**BEFORE THE BOARD OF PATENT APPEALS
AND INTERFERENCES**

Application Number: 09/839,509
Filing Date: April 20, 2001
Appellant(s): STRUHSAKER ET AL.

EXAMINER'S ANSWER

This is in response to the appeal brief filed 3-9-2006 appealing from the Office action mailed 5-3-2005.

Applicant's FIG. 4

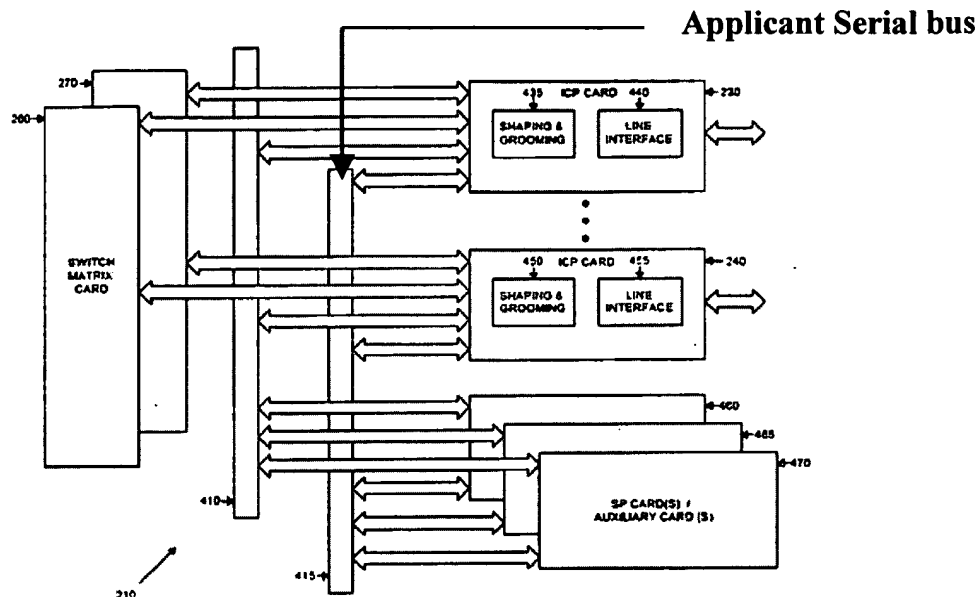
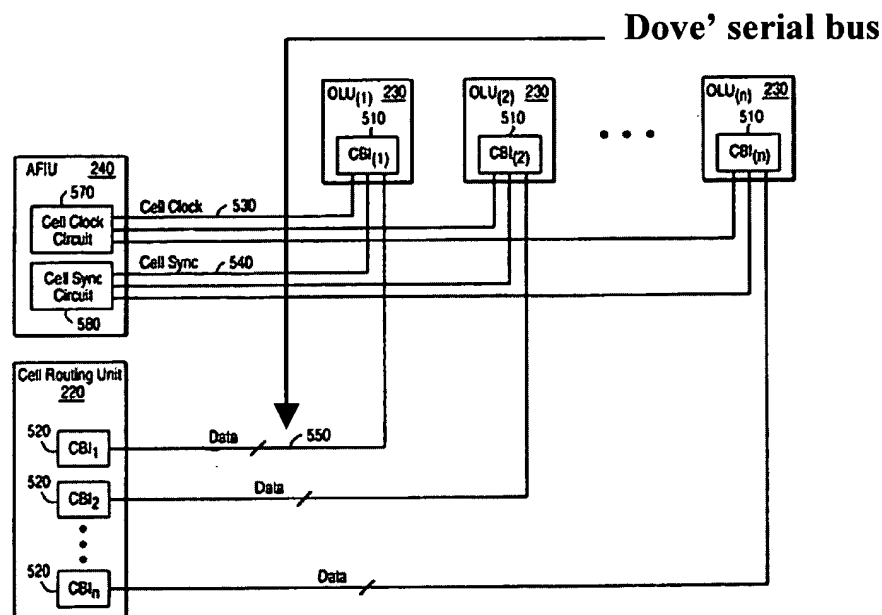
Third, examiner's interpretation of “serial link” neither contrary to specification nor ordinary and accepted meaning of the term since both applicant's serial bus/link 415 (see applicant FIG. 4) and Dove's serial link/bus 550 (see Dove's FIG. 5) are identical and performed identical functionality as shown below.

Fourth, Dove also discloses one or more point-to-point or serial link/bus 550 in col. 7, line 33-36, 55-56 as set forth below.

The cell bus of FIG. 5 supports a direct **point to point link** between the ATM switching fabric of the CRU 220 (FIG. 2) and each OLU 230. Within each cell bus frame, a complete ATM cell (53 bytes) is transferred across the cell bus.

As discussed above, **the data lines 550 are wired point to point from the CRU 220 to each OLU 230.** (Emphasis added).

Thus, it is clear that Dove's serial bus/link 550 clearly anticipates the applicant's "serial bus/link".

Dove's FIG. 5

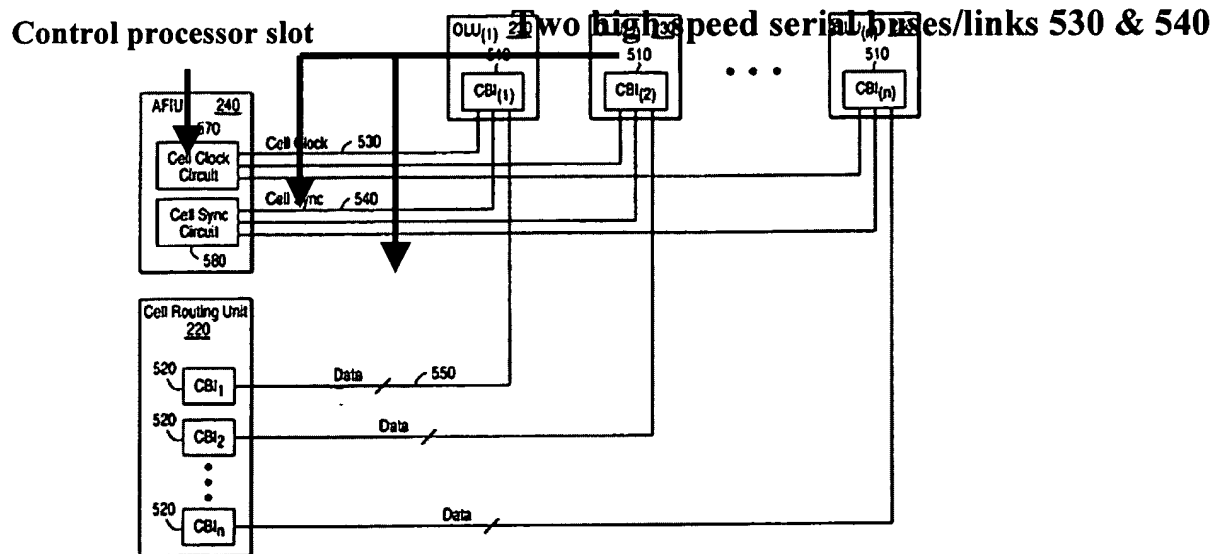
In response to applicant's argument, the examiner respectfully disagrees with the argument above. Dove discloses at least two (2) high speed serial links (see FIG. 5, Cell clock 530 and cell sync 540 between AFIU 240 and OLU 230; see FIG. 10, links between LIU 230 and ABIUs) for each interface control processor slot (see FIG. 5 and FIG. 2, AFIU 240) in said backplane (see col. 6, lines 5-67; see col. 5, lines 35-55; see col. 12, lines 12-30; see col. 7, line 15-21,33-37) as shown below.

Dove discloses high speed serial cell clock 530 bus/link and cell sync 540 bus/link at AFIU 240 (ATM Fiber Bank Interface Unit) as recited in col. 7, line 15-21,33-37. As set forth above, examiner is clearly asserting and reciting that a cell clock 530 link/bus and cell synch 540 links, not a single cell bus 500 argued by the applicant, anticipate applicant's "at least two high speed serial links for each interface processor slot".

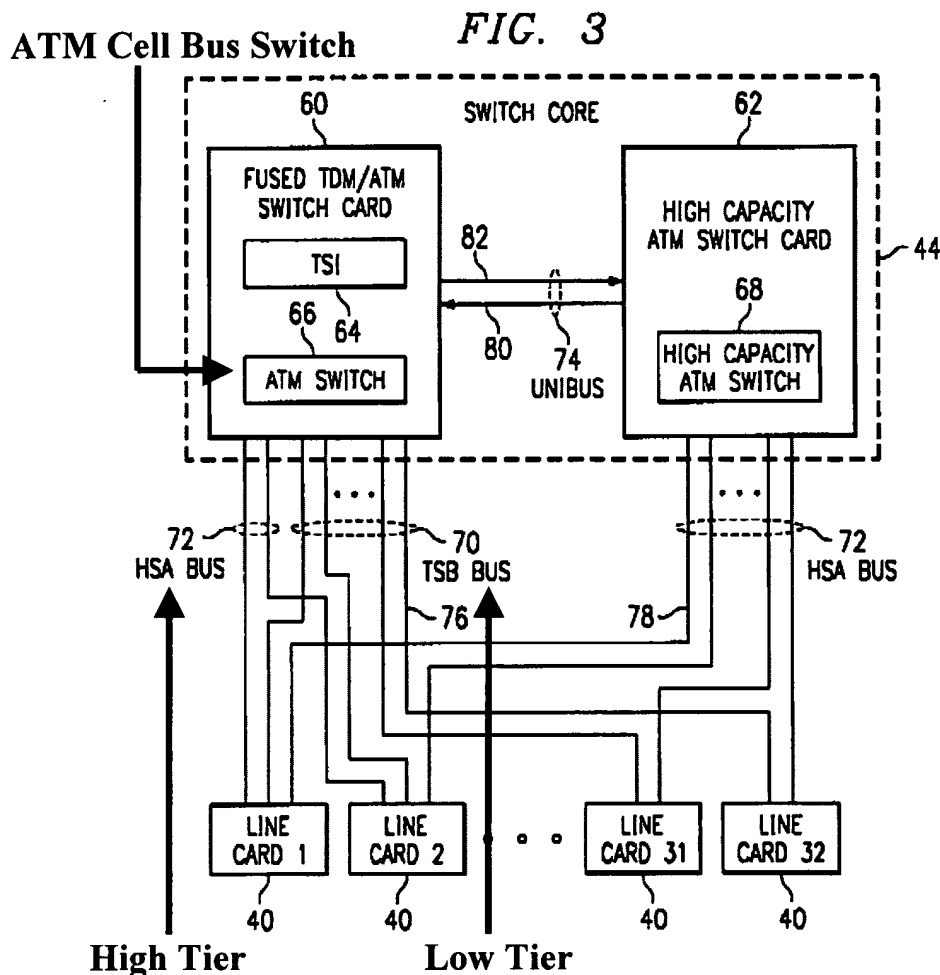
Moreover, Manchester TSB bus 70 is a point-to-point ATM “cell-based” bus since it is connected to ATM cell switch 66 as shown in FIG. 3 below.

Manchester discloses a point-to-point ATM “cell-based” switching (via ATM switch 66) in TSB bus 70 as described in col. 8, line 5-12,43-46,52-54 below.

Manchester also discloses a point-to-point or **serial** switching in HAS bus 72 as shown above and recited in col. 8, line 66 to col. 9, line 4 below.

Thus, it is clear that Manchester discloses precisely and clearly applicant’s claimed and argued invention of “cell-based” tier and “serial tier” buses/links.
